PERMIT

SEWAGE DISPOSAL SYSTEM

HOWARD COUNTY HEALTH DEPARTMENT

SUBDIVISION Crystal Clear LOT 26 ROAD 13835 Kennard Drive

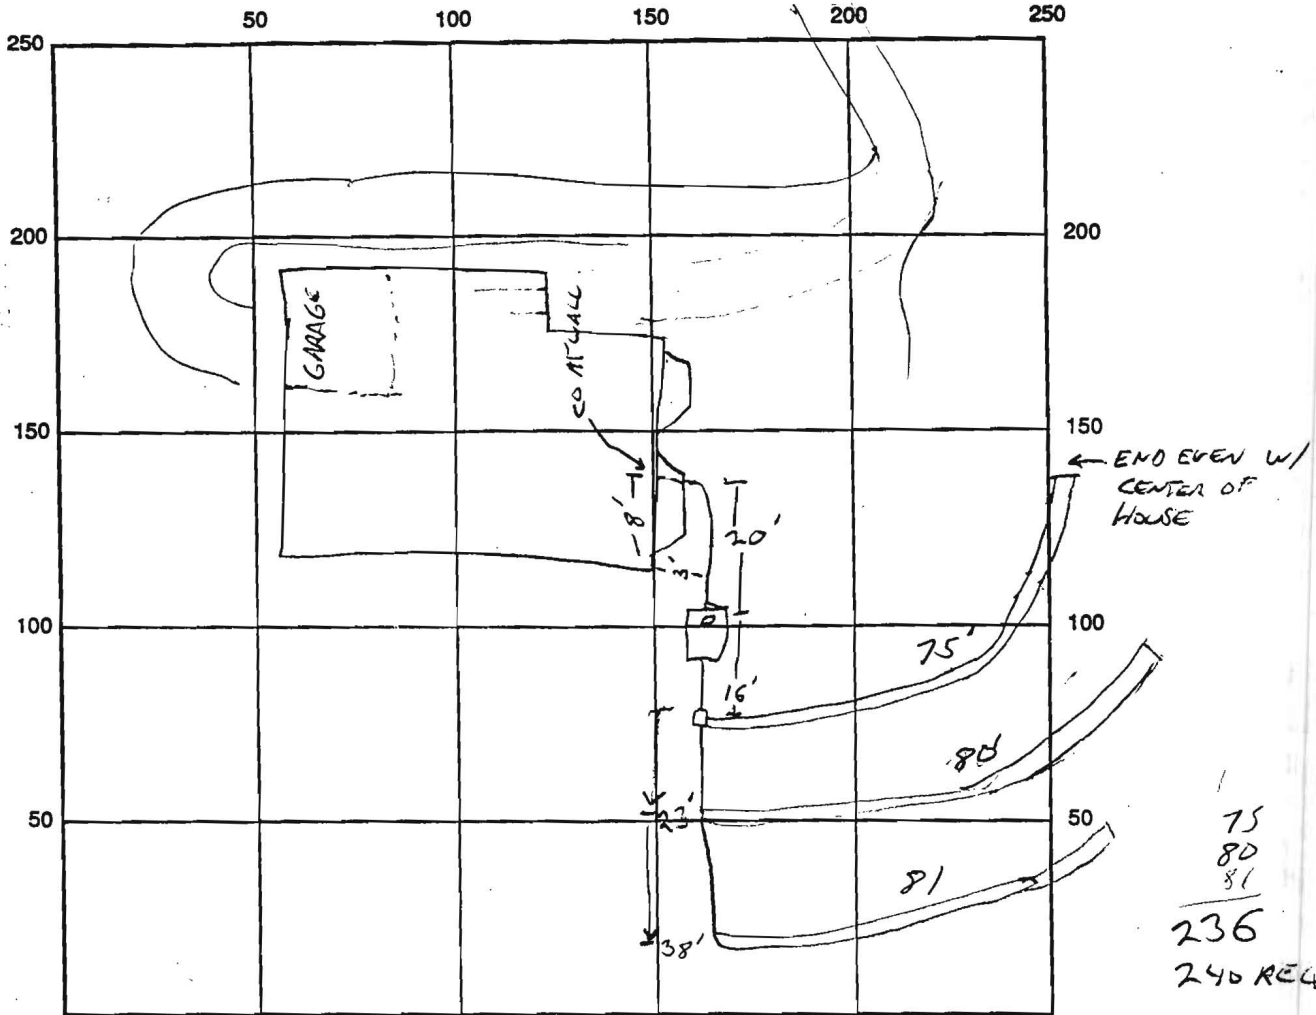
REMARKS: HOUSE CLEANOUT NOT CEMENTED, TRENCHES 4' SHORT OF REQUIRED LENGTH,
PASSIBLY DUE TO METHOD OF MEASUREMENT. 6-2-95

6/2 CALLED ARNOLD BACKHOE & SEPTIC, ADVISED THEM OF THE NEED
TO CEMENT THE HOUSE CLEANOUT. BACKHOE OK. PERM CARD NEEDS
TO BE SIGNED SINCE NEITHER CONTRACTOR OR THE PERMIT WERE ON
SITE DURING INSPECTION
